**CHARTER TOWNSHIP OF VAN BUREN  
PLANNING COMMISSION AGENDA  
Wednesday, August 10<sup>th</sup>, 2022 – 5:30 PM  
Van Buren Township Hall  
46425 Tyler Road**

**Subject: VBT-22-012 Chahal Transport - Schooner Drive; Special Land Use Review #1  
Revised Site Plans Dated February 16, 2022 (Received May 17, 2022)**

**Subject: VBT-22-012 Chahal Transport - Schooner Drive; Site Plan Review #3  
Revised Plans Dated June 21, 2022 (Received July 5, 2022)**

## **Chahal Semi Truck/Trailer Repair Facility Site Plan Preliminary Site Plan Review #2**

LANDSCAPE PLAN FOR:  
Davenport Brothers Construction  
301 Industrial Park Drive  
Belleville, Michigan 48111  
(734) 697-2994

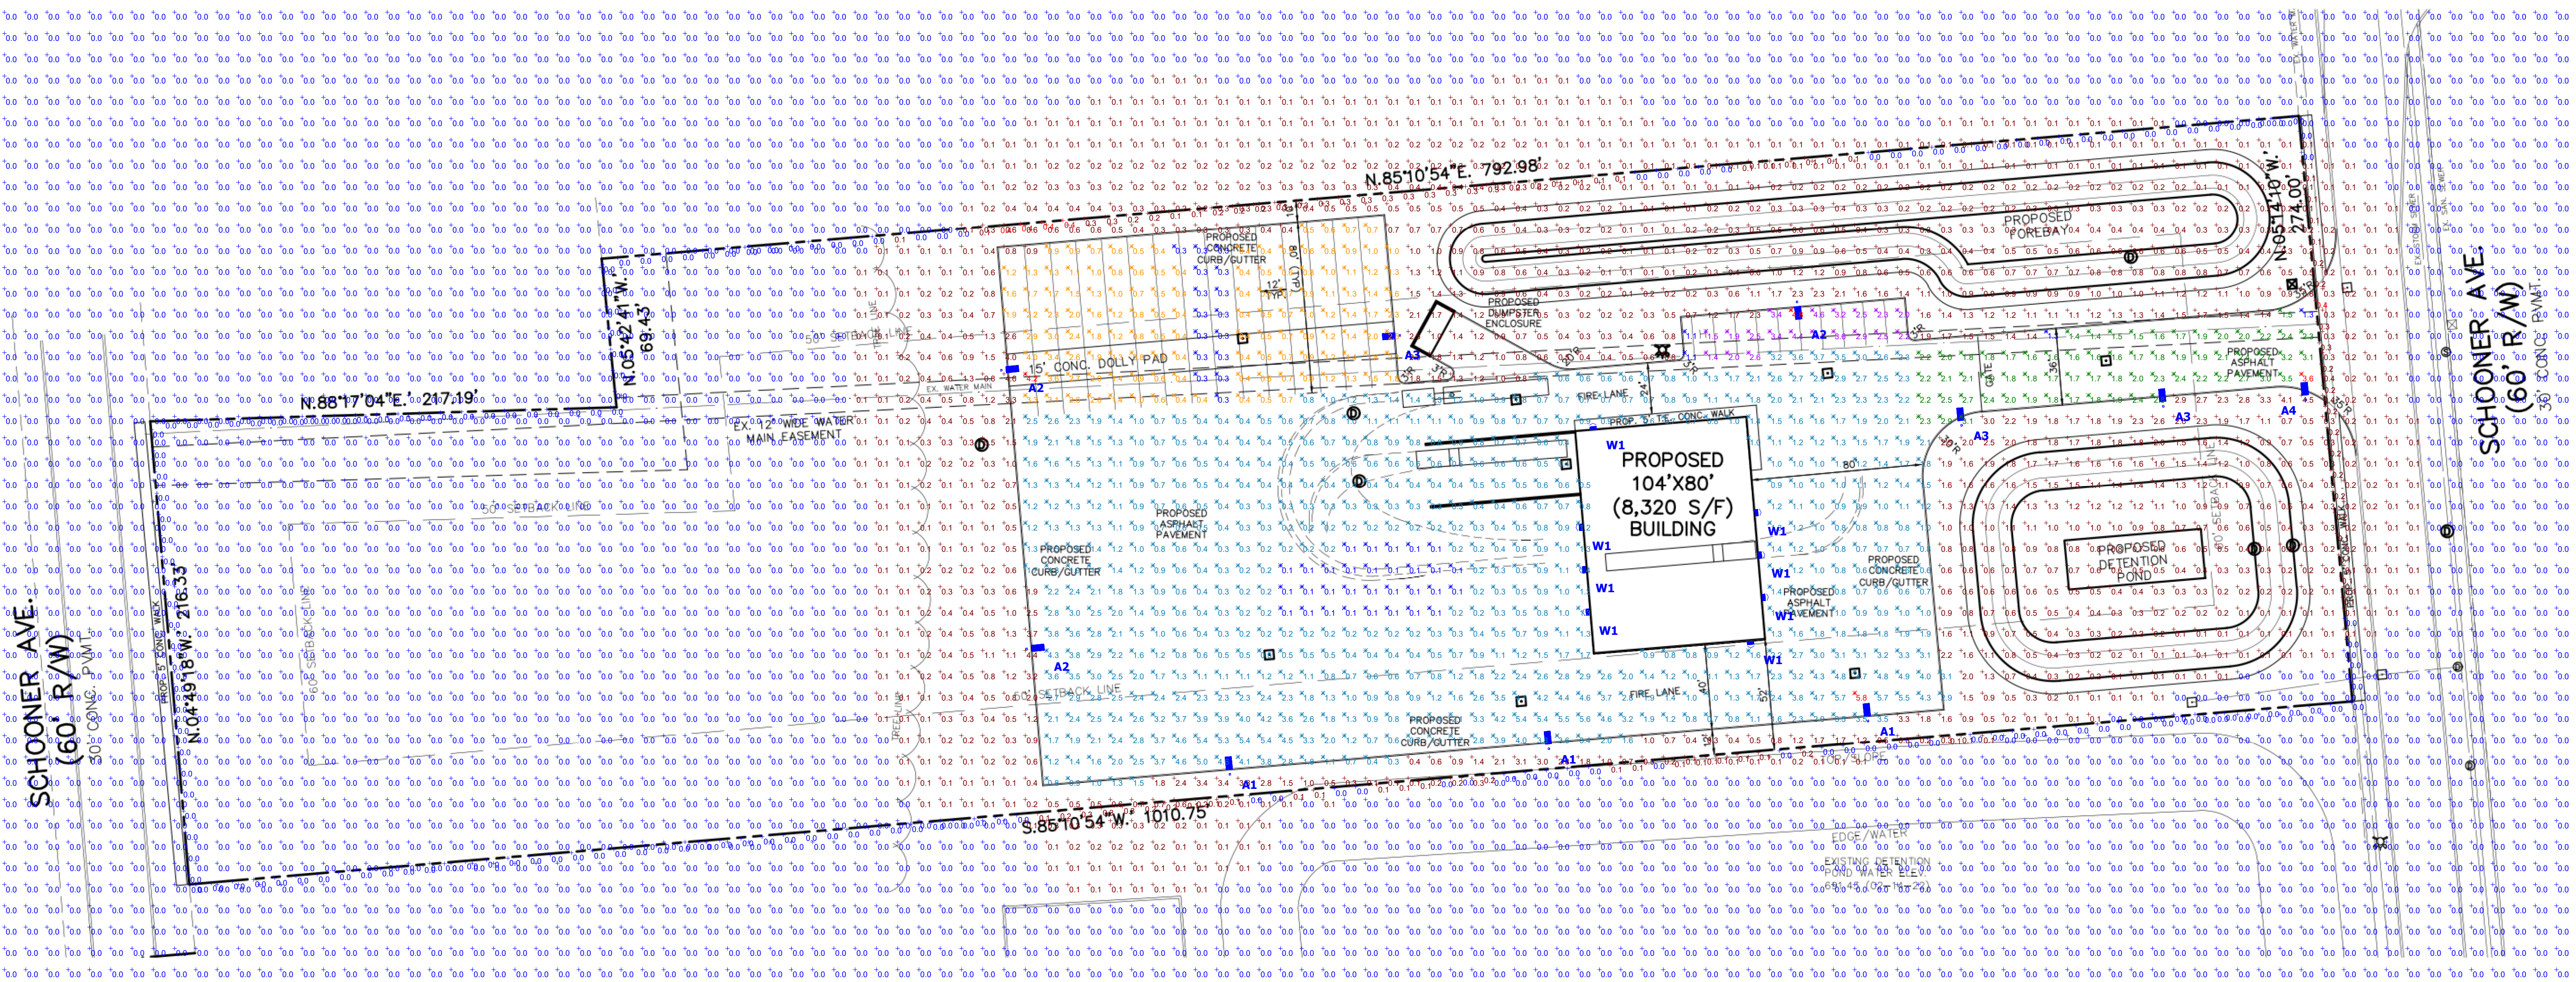
- a. **Landscaping Adjacent to Right-of-Way.** Section 10.103(A) requires lot frontage landscaping of 1 deciduous or evergreen tree/40 lineal feet + 1 ornamental tree/100 lineal feet + 8 shrubs/40 lineal feet. Per the landscape plan calculations, the site has a frontage of 274 feet – 36 feet driveway, or 238 feet on Schooner Drive (east). The site also has frontage Schooner Drive (west), however, the existing tree line to the west is to be preserved.

The site plan rounds up frontage to 240 feet. The site requires a total of 6 deciduous or evergreen trees + 3 ornamental trees + 48 shrubs along the site's frontage. The applicant has provided 10 deciduous or evergreen trees + 3 ornamental trees + 49 shrubs along the Schooner Drive frontage.

**Interior Parking Lot Landscaping.** Section 10.103(B)(2) requires the provision of landscaping within islands in a parking lot. Interior landscaping shall account for a minimum of five percent (5%) of all paved parking areas, including parking and loading spaces, driveways, and aisles. The applicant has indicated there is a total of 88,352 sq. ft. of parking area, which requires a total of 4,418 sq. ft. of interior parking lot landscaping; the applicant has noted the provision of 6,080 sq. ft. of interior parking lot landscaping. Additionally, one (1) deciduous tree is required to be planted for each three hundred (300) square feet of interior landscaping, which the applicant has provided.

- e. **Open Space Landscaping.** All remaining open areas on the site that are not required landscaping areas as described elsewhere in this Article shall be planted with one (1) deciduous or evergreen tree per three thousand (3,000) square feet of open area. The applicant has noted that 20,644 sq. ft. of open area remains beyond the required landscaping areas and has provided seven (7) deciduous trees to meet the ordinance requirement.

7. **Tree Removal Permit.** The plans submitted do not include a detailed tree inventory of all the trees on the site, which has been repeatedly requested. The final submittal must include a tree survey identifying all regulated trees, i.e., trees with a d.b.h 5" or greater on the site. The tree survey can be limited to the area of disturbance if the limits are clearly specified. The wooded area on the rear of the site, if left undisturbed, need not be surveyed. A summary table of total number of trees on site, total number of regulated trees, trees to be preserved and trees to be removed, must be provided. All regulated trees to be removed must be replaced in accordance with Section 8.106 (J) of the Zoning Ordinance and clearly identified on the landscape plan. Required landscaping cannot be counted towards replacement.

Semi-Truck Repair Facility - Schooner Road  
PHOTOMETRIC SITE PLAN  
PREPARED FOR: GRAYBAR  
GASSER BUSH ASSOCIATES  
WWW.GASSERBUSH.COM

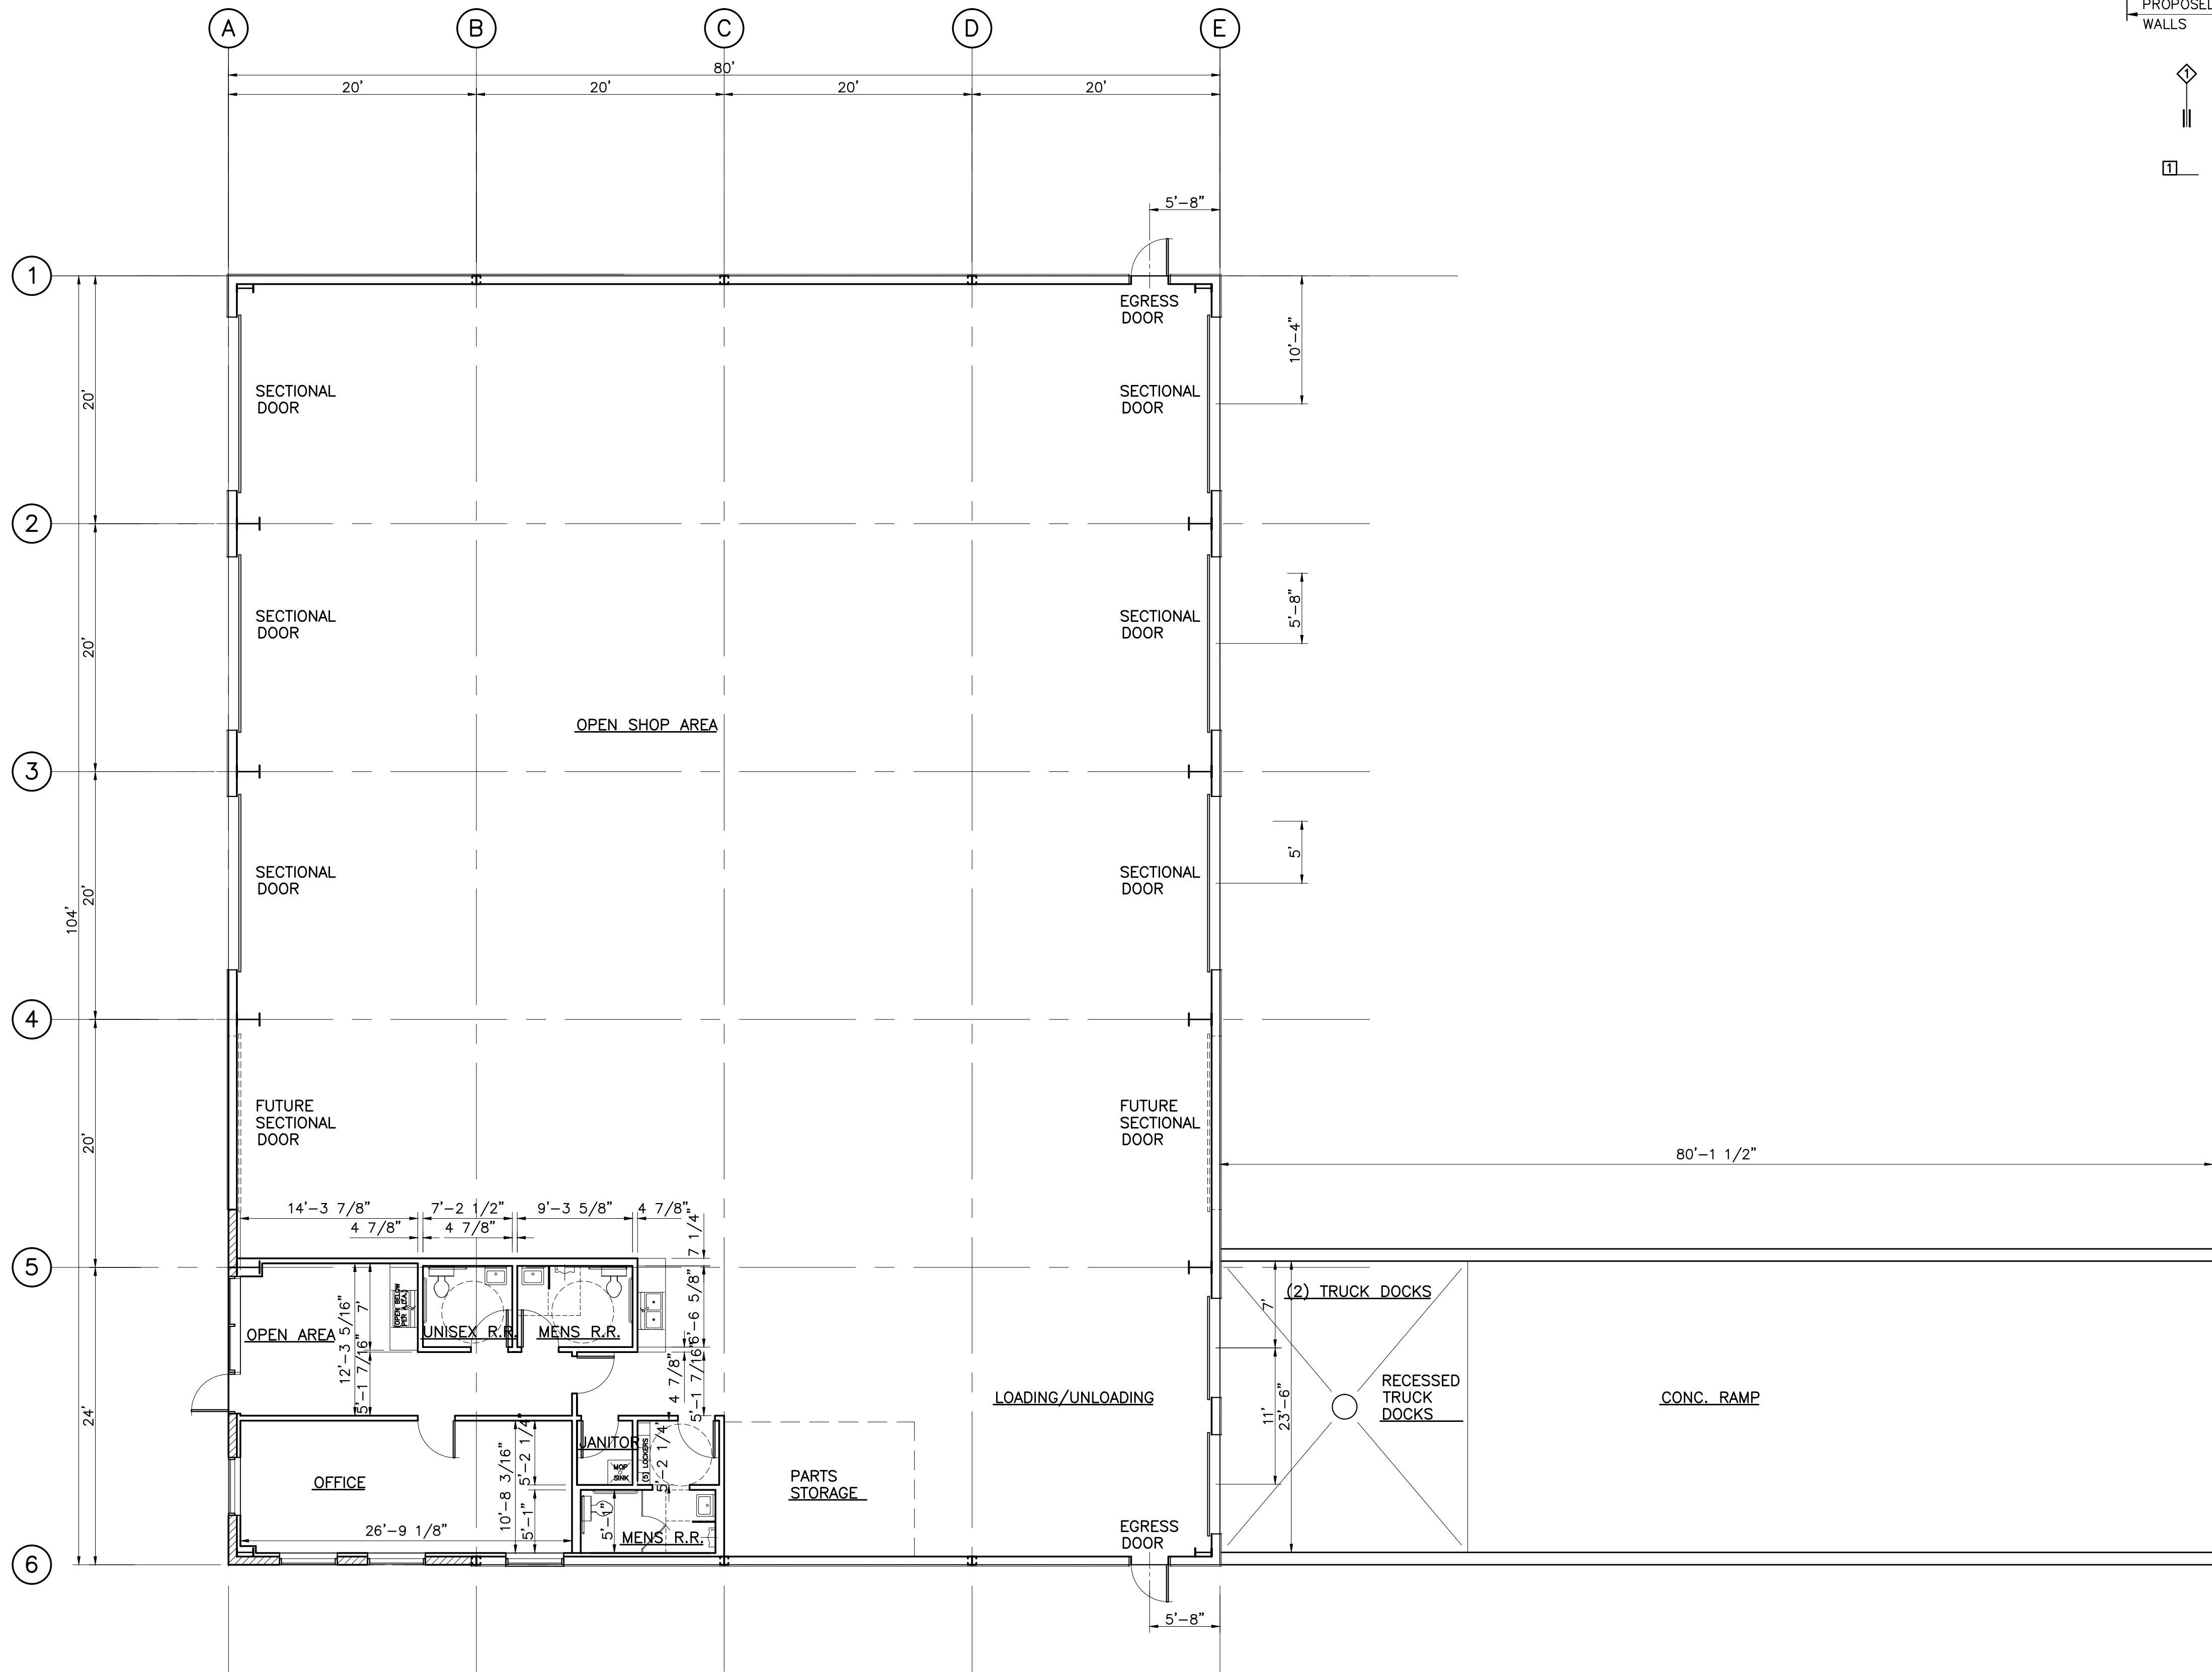
9. **Lighting.** The applicant has submitted a photometric plan for the site. The plan proposes nine (9) 25-foot light poles for parking lot illumination and eight (8) exterior wall fixtures mounted at 15 feet. Manufacturer's cut sheet detail for proposed fixtures have been provided and are acceptable. As previously recommended, consistent with all other developments on Schooner Drive, the revised plan notes a single 15' tall pole to the access drive for safety and clear visibility for emergency vehicles accessing the site. Light trespass into adjacent lots does not exceed 0.5 fc. The proposed illumination intensity on the site complies with the requirements of Section 8.105 (B)(2).
